7. Nakada Subdivision Alexson Replat

KPB File 2023-126

**ITEM #7 - PRELIMINARY PLAT
Nakada Subdivision Alexson Replat**

STAFF REPORT

NAKADA SUBDIVISION ALEXSON REPLAT

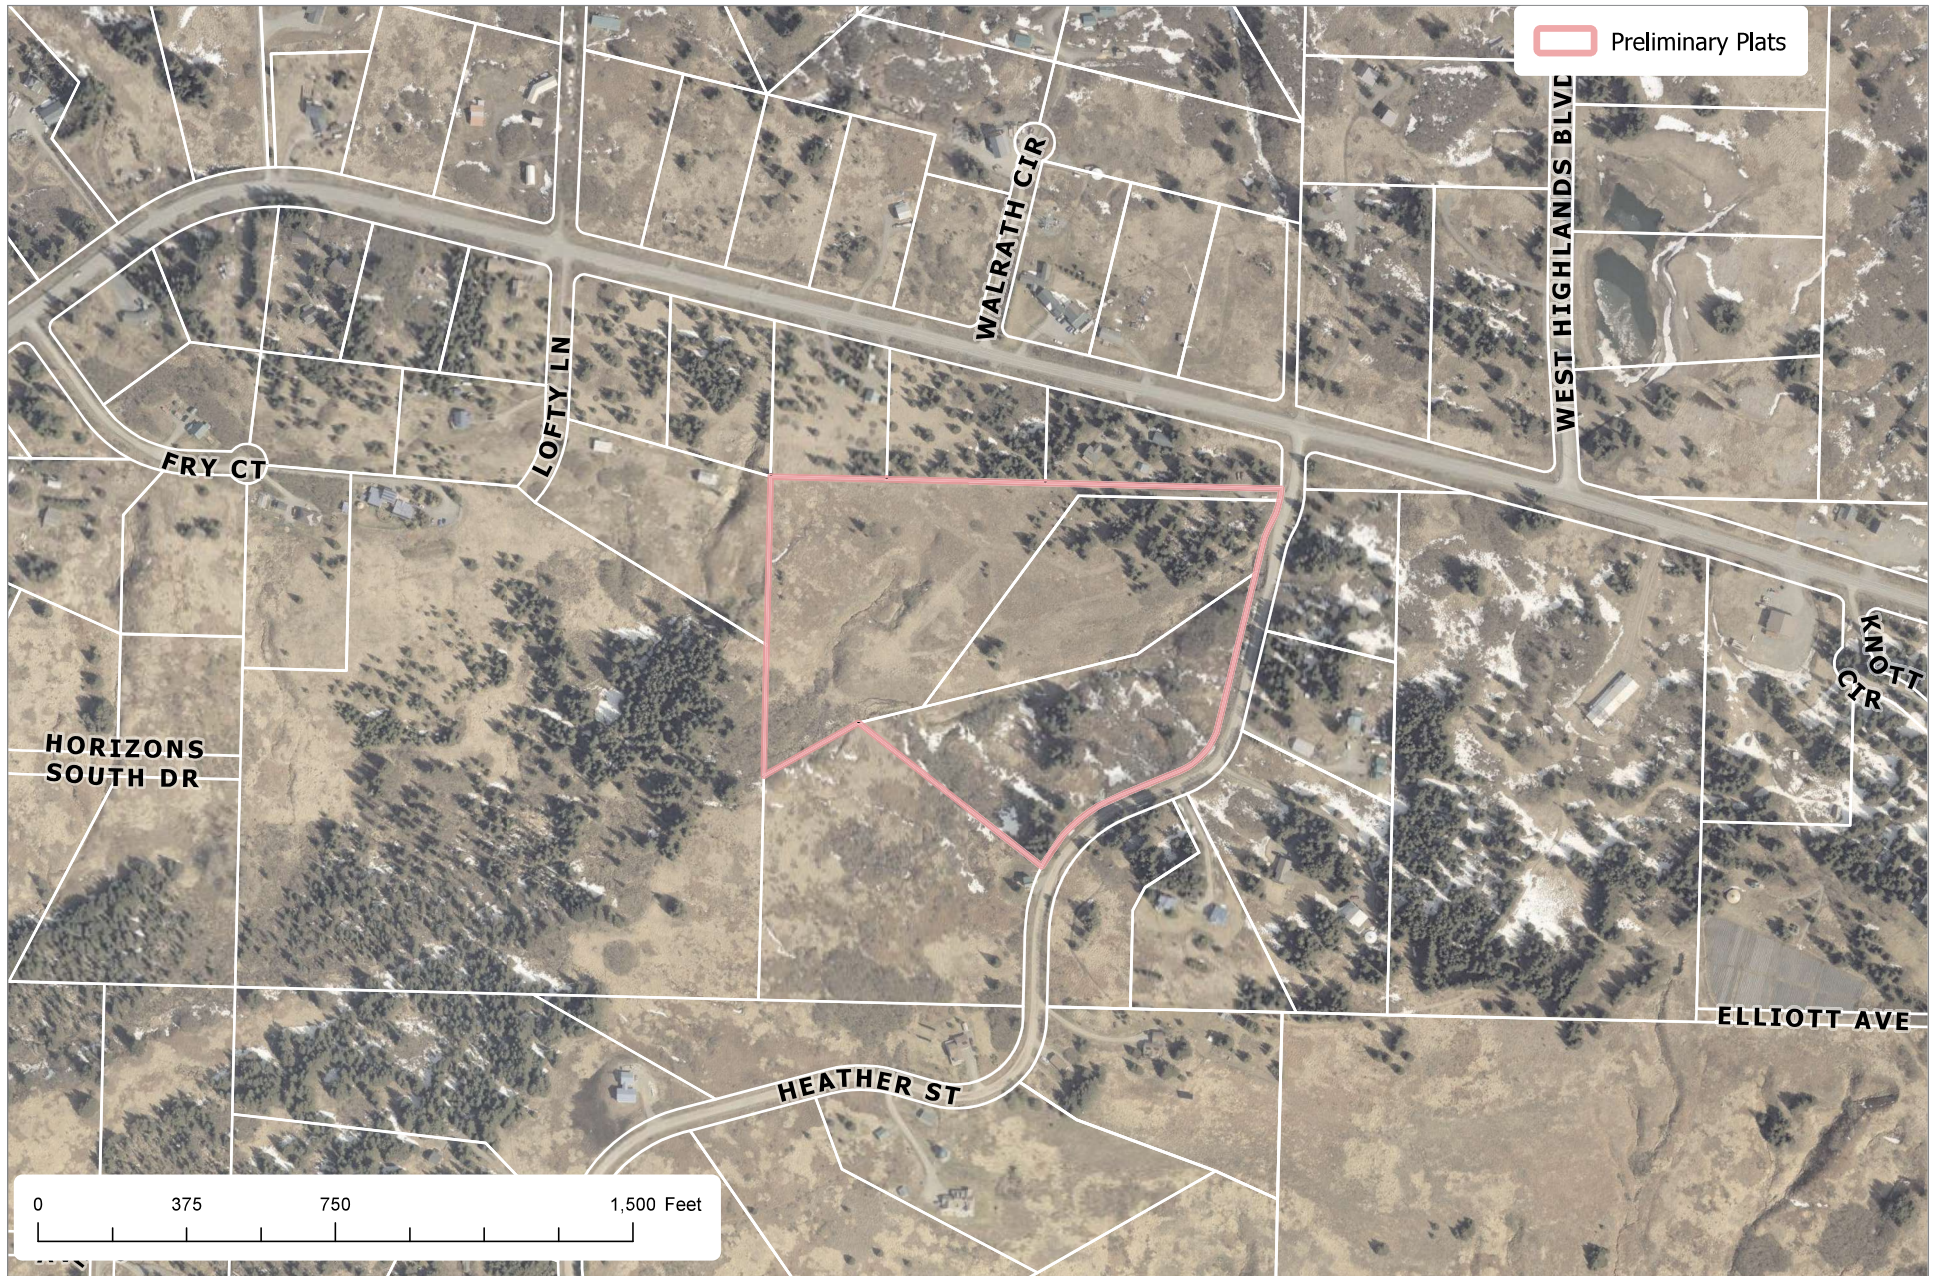
No new dedication is being proposed and a section line easement does not affect the property. There appears to be a section line easement to the northeast going north up Heather Street from the plat boundary and across Diamond Ridge Road, this easement should be confirmed and shown on the drawing.

Areas with slopes greater than 20 percent are shown on the plat. These should be changed to top of slope and toe of slope for the final and shading removed.

There are wetlands shown on the plat and should remain shown on the final.

There is a private ingress-egress easement listed in plat note #6 at document HM 2004-005555-0 that the location should be shown on the final.

Add 2023-126 to KPB No.

Add 'aka Pete' to the owner's name as it is being used in the Certificate of Ownership and Dedication.

Add the street name and ROW to Diamond Ridge Road.

Add the section line easement above the section to the east unless it is found to be vacated also.

Label ROW of Heather Street above section line.

Label the rivers and creeks on the map

Show and label Heather Street

The parcel northeast of the subdivision needs labeled with lot and plat label.

Curve and line table needs a note as to if they are listing recorded or measured data and then opposing data given.

- The borough will not enforce private covenants, easements, or deed restrictions per KPB 20.60.170.

Add the date of December 11, 2023 to the Plat Approval
